Subject: AP1000 Response to Request for Additional Information (SRP TR44)

AP1000 TECHNICAL REPORT REVIEW

RAI Response Number: RAI-TR44-011
Revision: 2

1. APP-GW-GLR-026, Revision 0, May 2006, "New Fuel Storage Rack Structural/Seismic Analysis," (Technical Report Number 44, TR44)
2. Westinghouse Calculation APP-GW-S2R-010, Revision 2, May 2008, "Extension of NI Structures Seismic Analysis to Soil Sites" (Technical Report Number 3, TR03)
3. APP-GW-GLR-026, Revision 3, May 2010, "New Fuel Storage Rack Structural/Seismic Analysis," (Technical Report Number 44, TR44)
4. Westinghouse Calculation APP-GW-S2R-010, Revision 4, March 2010, "Extension of NI Structures Seismic Analysis to Soil Sites", (Technical Report Number 3, TR03)

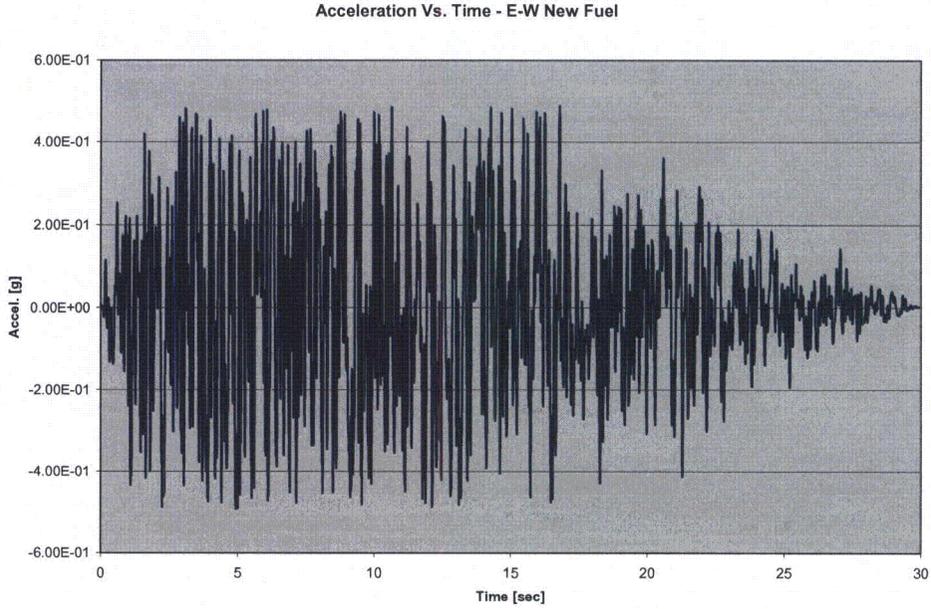
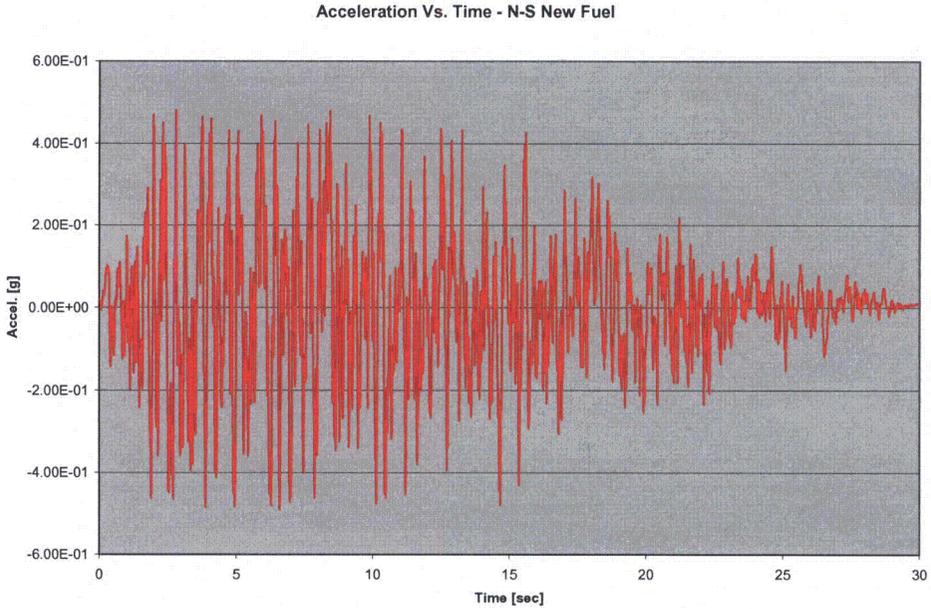
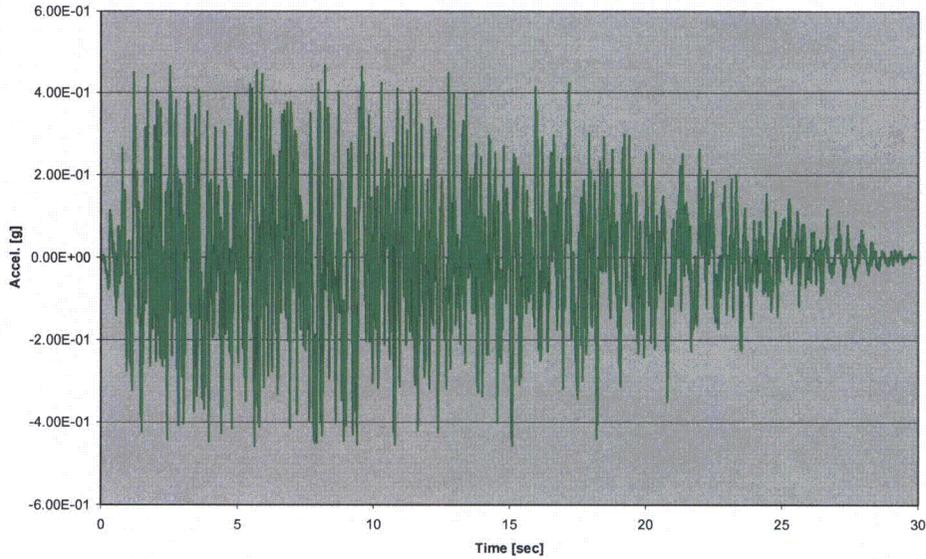
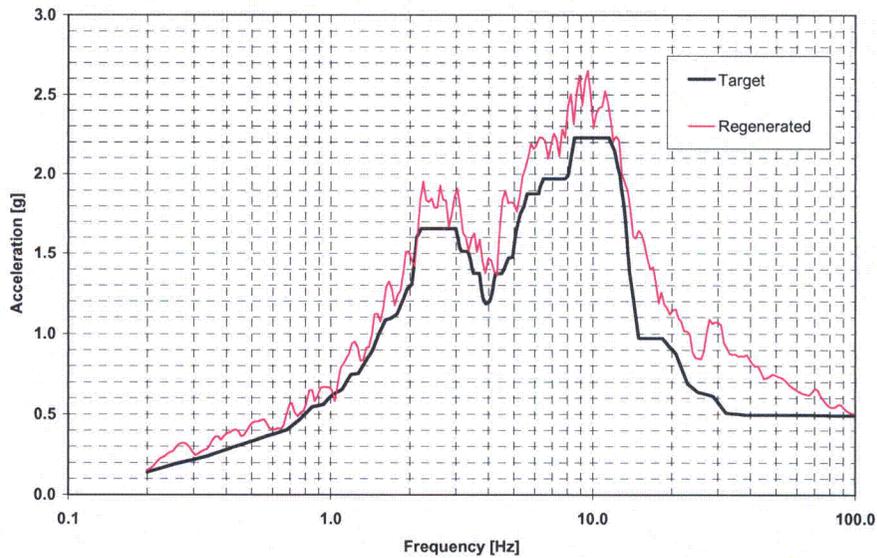
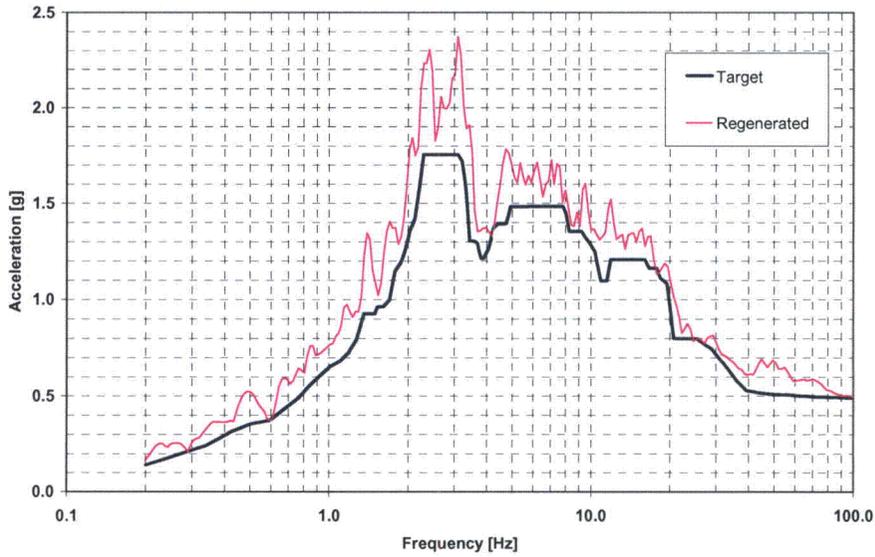
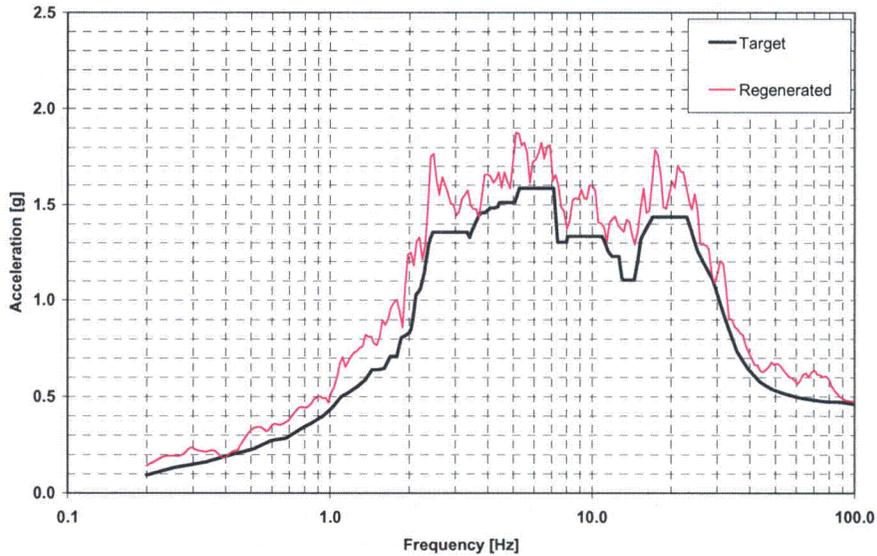
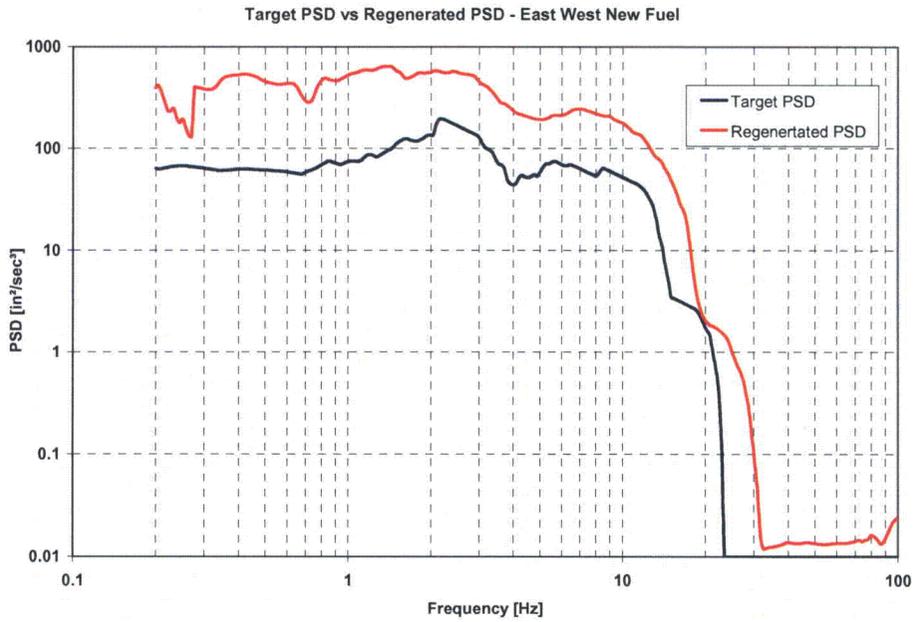
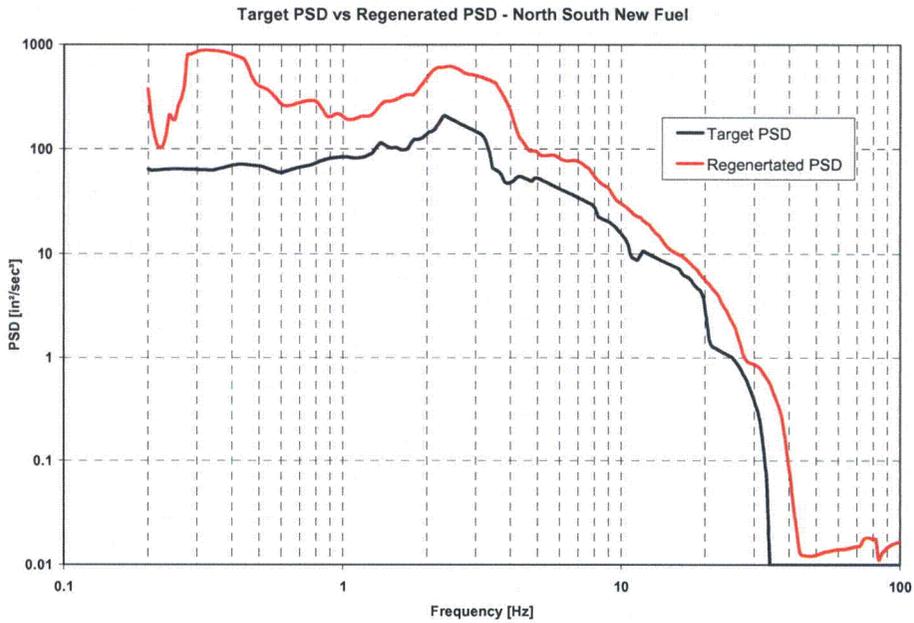
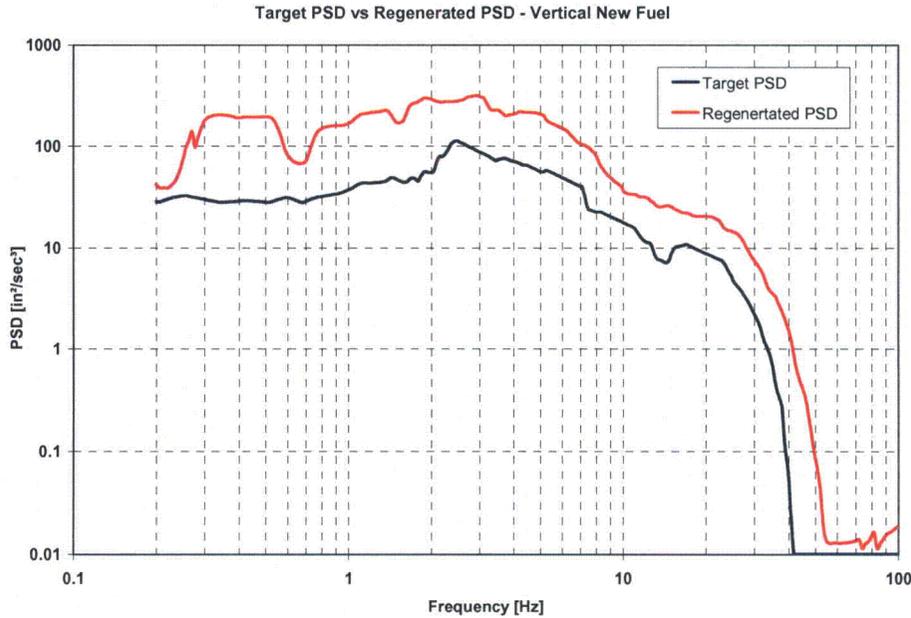
- (d) For the synthetic time histories, provide plots of the three time histories, the cross correlation coefficients, the comparisons of the spectra from the synthetic time histories to the enveloped target response spectra, and the comparisons of the power spectral density plots to the target power spectral density function associated with the target response spectra.

Therefore Westinghouse considers all of the responses submitted in Rev. 0 of this RAI for the new fuel rack to be technically acceptable as well; however, the input floor response spectra was revised since Rev. 0 was submitted. Following are updated responses to account for those changes.

- d) The synthetic time histories, the response spectrum curves, and the power spectral density plots for the new fuel storage vault inside the Auxiliary and Shielding Building (ASB) at Elevation 116' - 6" (the bottom of the new fuel vault is at Elevation 118' - 2.5") are provided in Figures TR44-11.1 through TR44-11.9. The cross correlation coefficients for the three orthogonal components (East-West, North-South, and Vertical) of the "New Fuel" synthetic time histories are summarized in the table below.
